PIC18F2525/2620/4525/4620

PIC18F2525/2620/4525/4620 Rev. A3 Silicon Errata

FIGURE 1: SCK PULSE VARIATION USING TIMER2/2

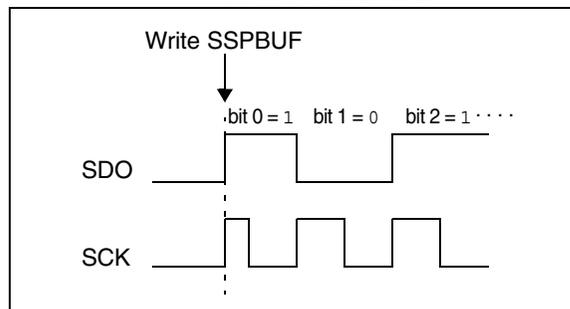
When the SPI is using Timer2/2 as the clock source, a shorter than expected SCK pulse may occur on the first bit of the transmitted/received data (Figure 1).

To avoid producing the short pulse, turn off Timer2 and clear the TMR2 register, load the SSPBUF with the data to transmit and then turn Timer2 back on. Refer to Example 5 for sample code.
